DEVIATION TO APPROVED PLAN
 No. 0340-06-97-4

PROJECT NAME & CLIENT INFORMATION
 AS BUILT DRAWING
 HOUSE ALTERATIONS AND ADDITIONS FOR DANIEL PLANAGAN
 SITE DESCRIPTION
 513 70 OF LOT 958 DURBAN NORTH
 25 WINDSOR DRIVE DURBAN NORTH

DRAWING DESCRIPTION
 PLANS SECTIONS AND ELEVATIONS

INCORPORATING APPROVED PLAN AS BUILT
 29/10/97
 5/11/1999
 [Signature]

SCALE	DATE	BY	REVISION
1/100	19/08/99	MB	
PROJECT NO. - DRAWING NUMBER			
9701A/01

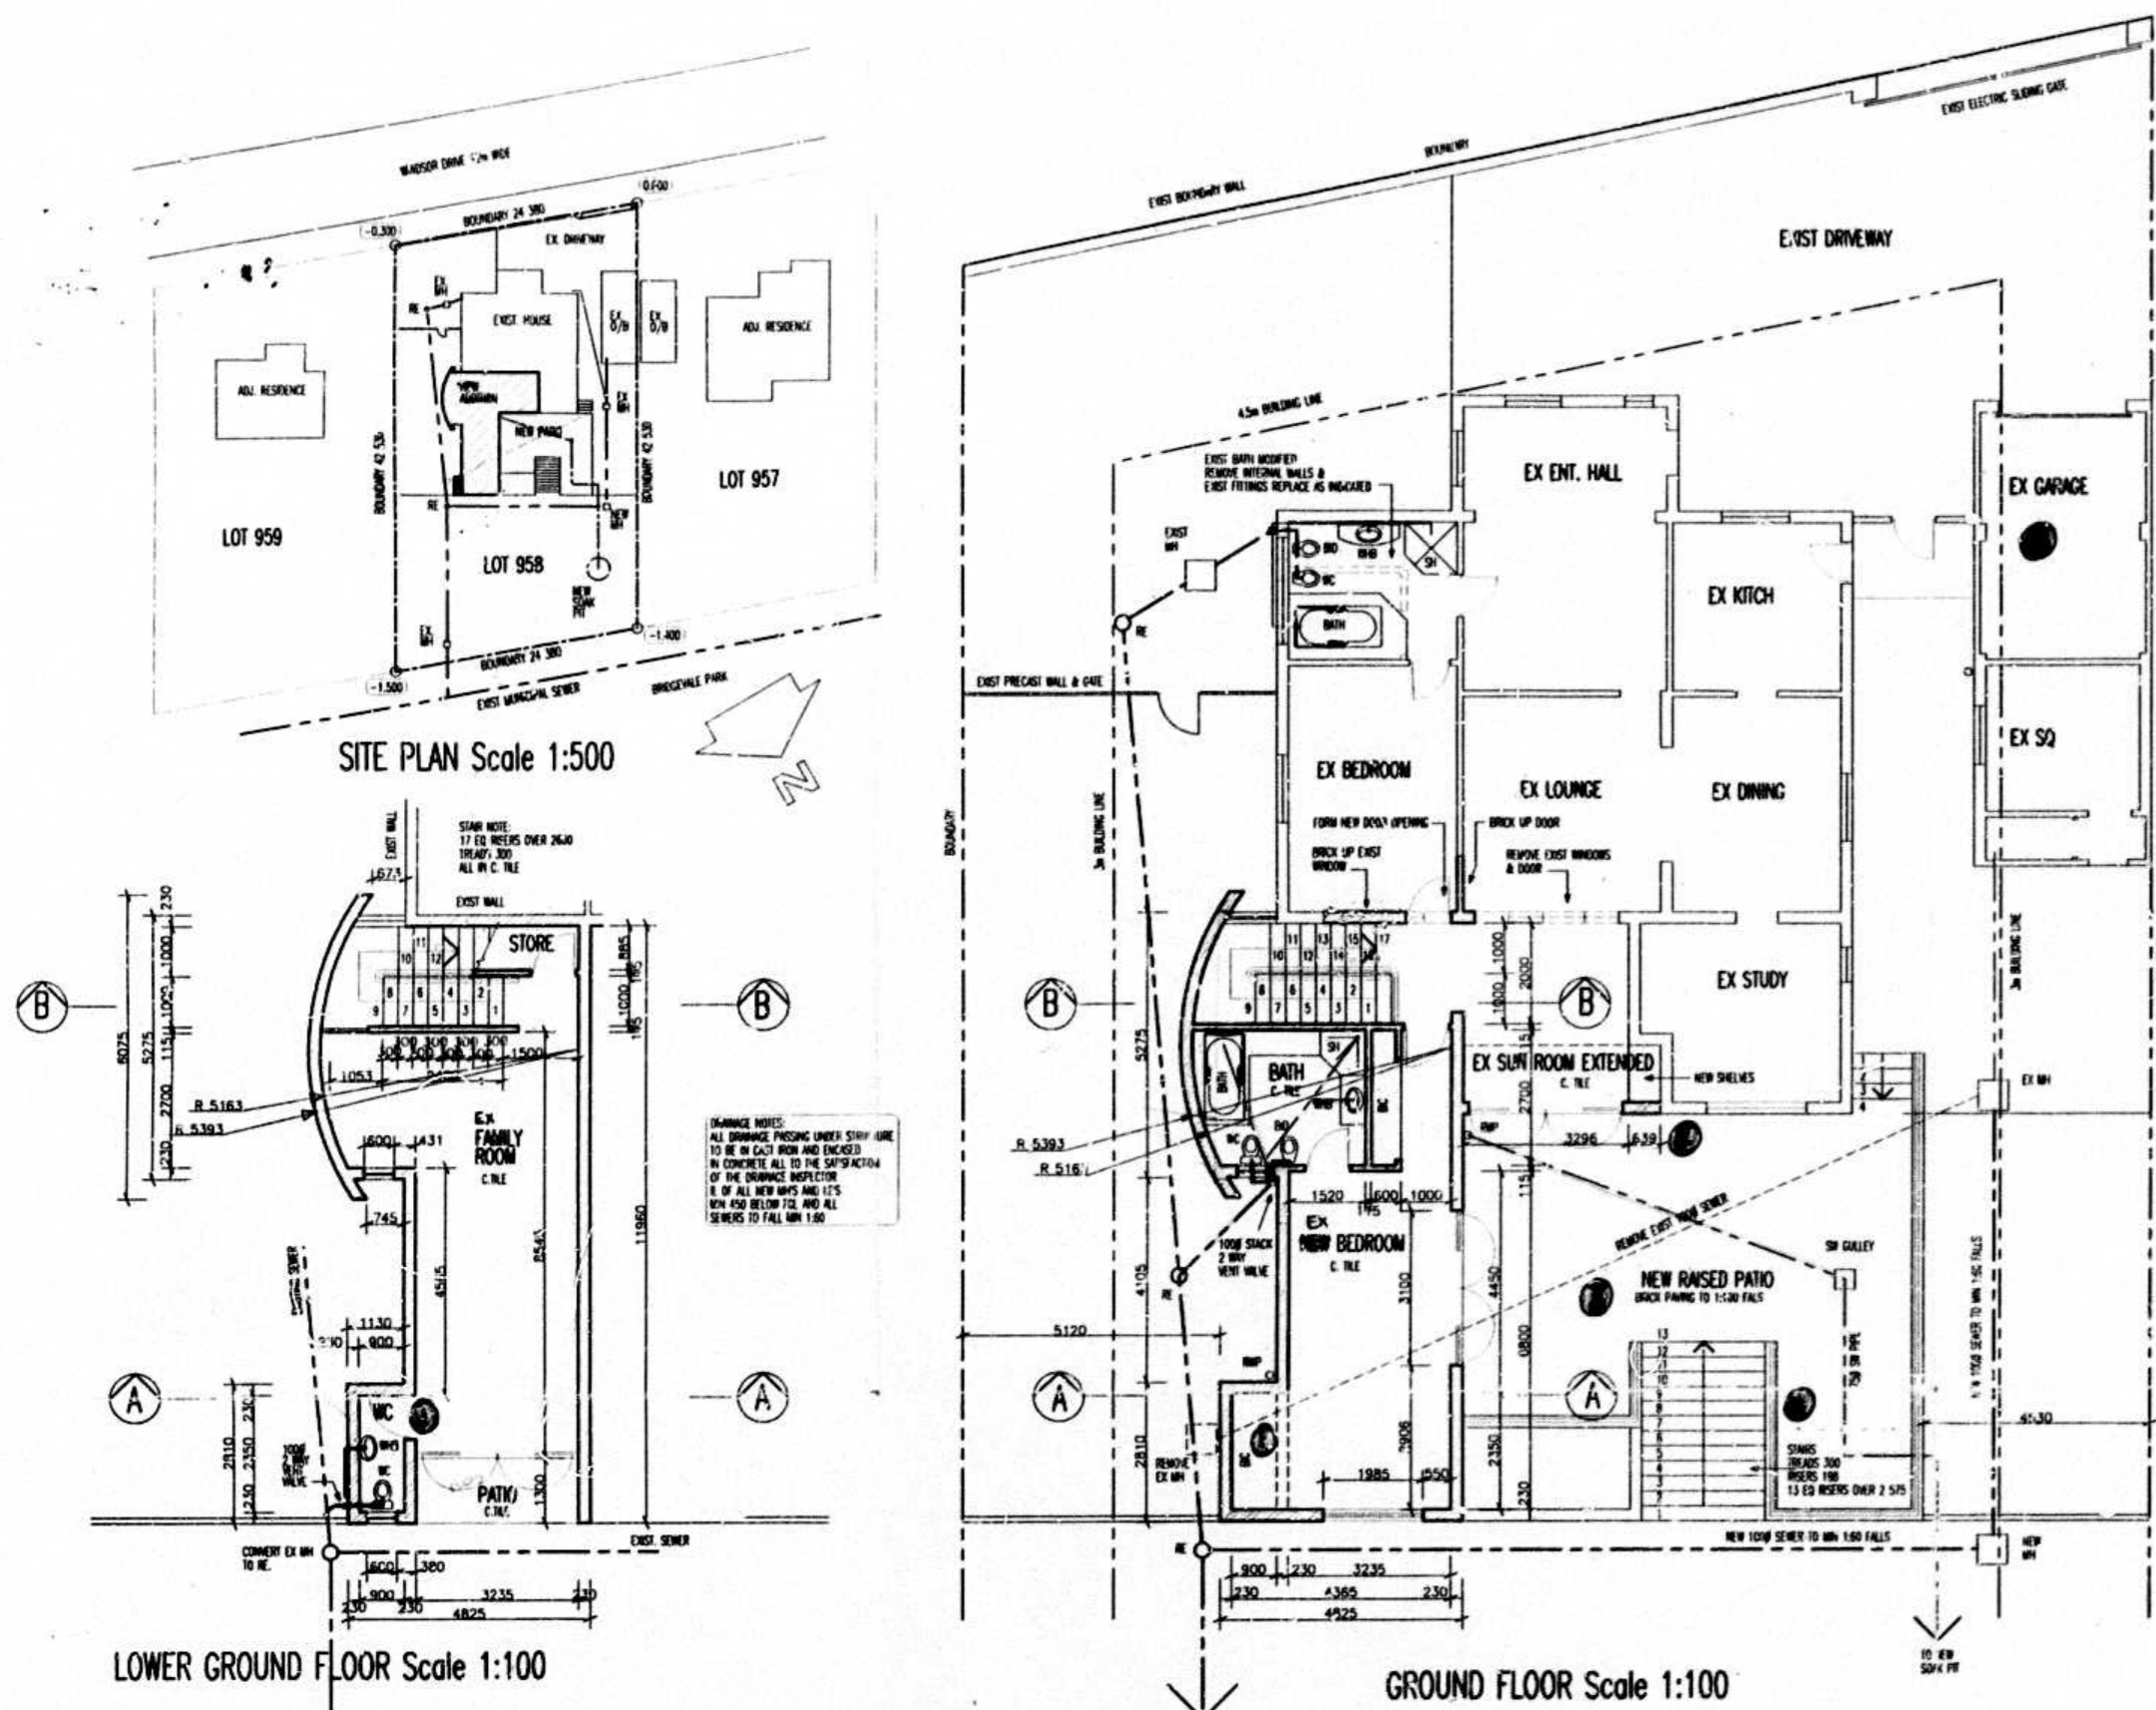
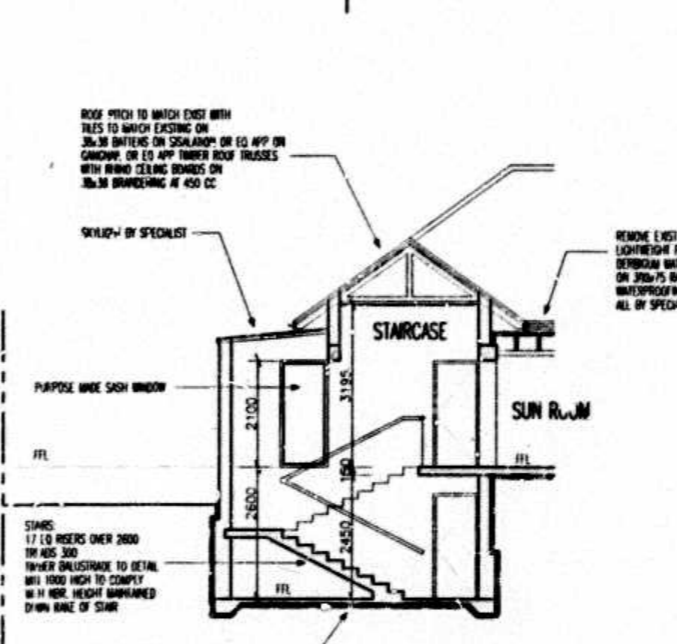
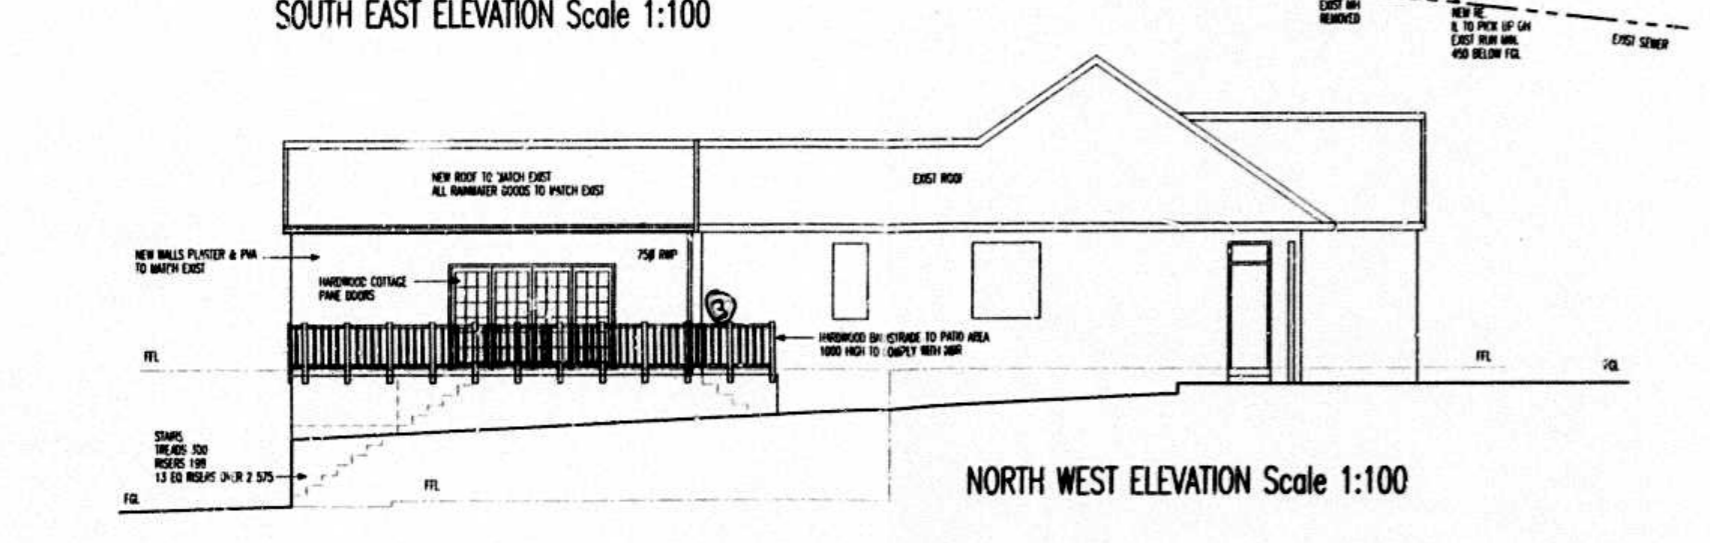
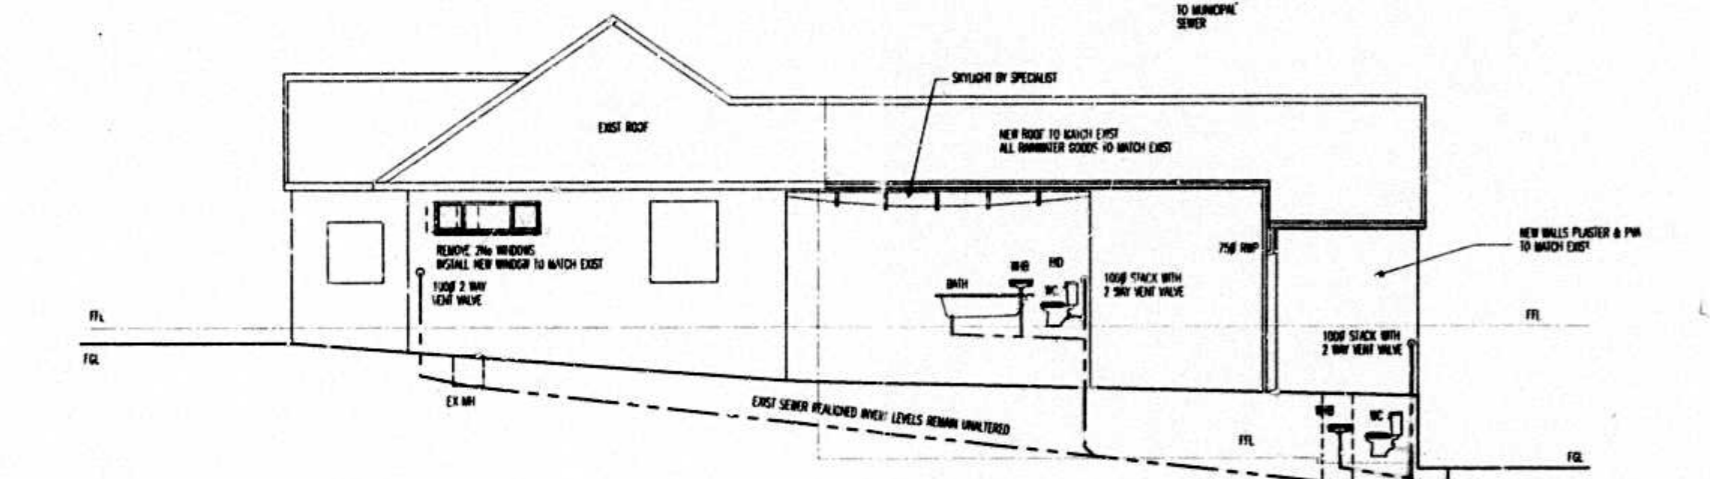
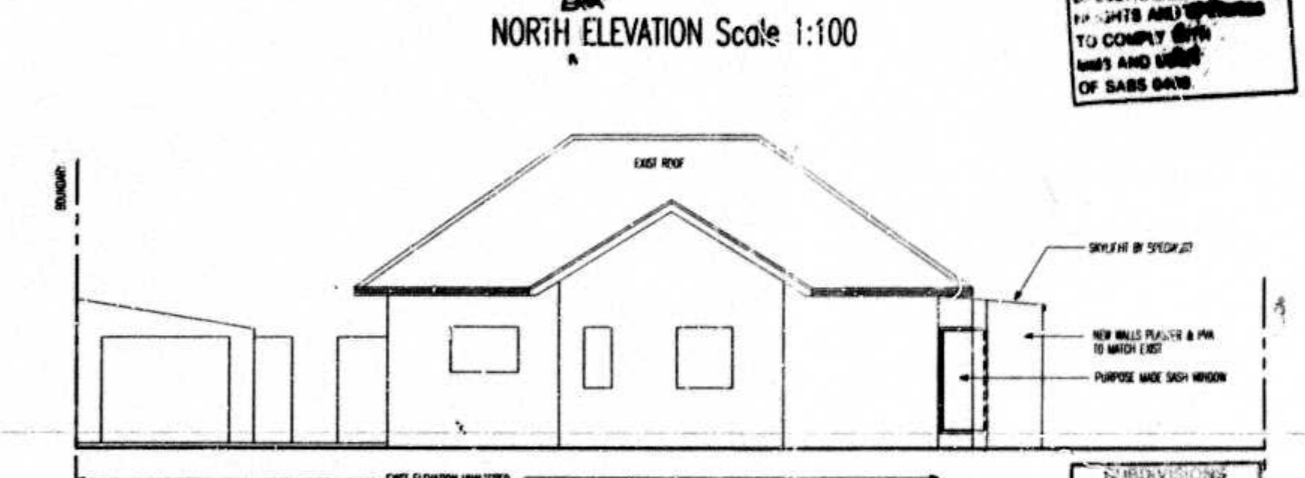
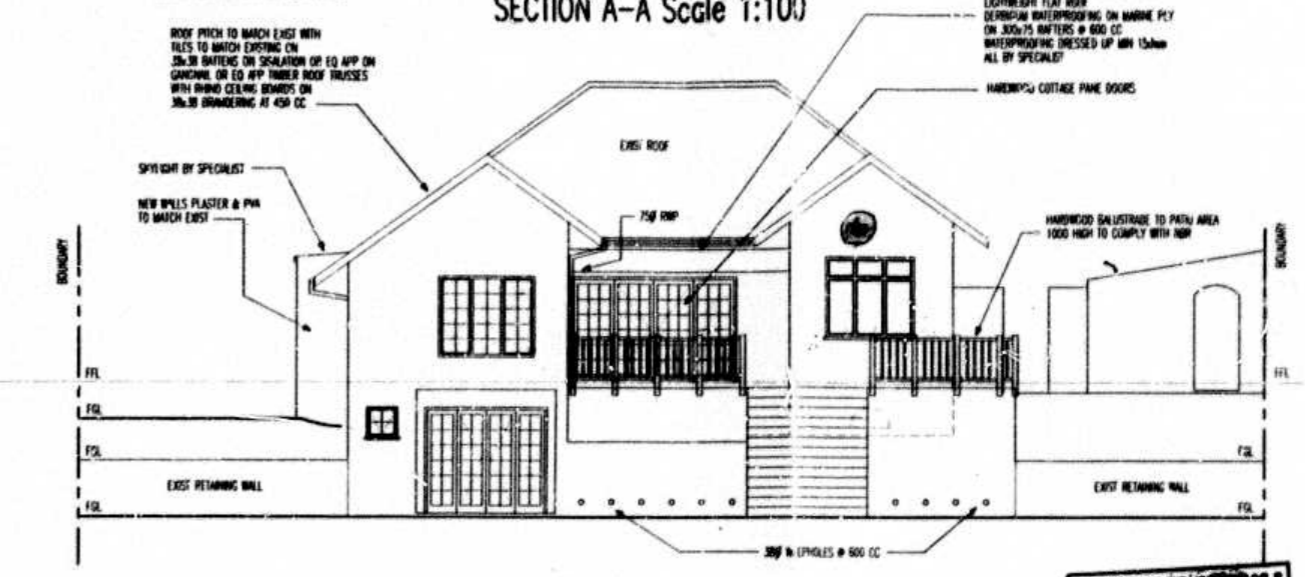
- LIST OF DEVIATIONS:
1. NEW TOILET COMPARTMENT ADDED TO FAMILY BATH AND EXTENDED UP TO BEDROOM AS A CLOSET.
 2. THE SUNROOM ON THE GROUND FLOOR WAS BEING EXTENDED UP BY 600 MM.
 3. A CONCRETE PATIO HAS BEEN ADDED IN LIEU OF A TIMBER SUNSCREEN.
 4. THE STAIRWAY HAS BEEN REPERFORMED.
 5. THE EXISTING GARAGE HAS NOT BEEN EXTENDED TO A DOUBLE GARAGE.
 6. THE EXISTING WINDOW ON THE PATIO WAS NOT BEING REPLACED WITH HARDWOOD COTTAGE PANE DOORS.
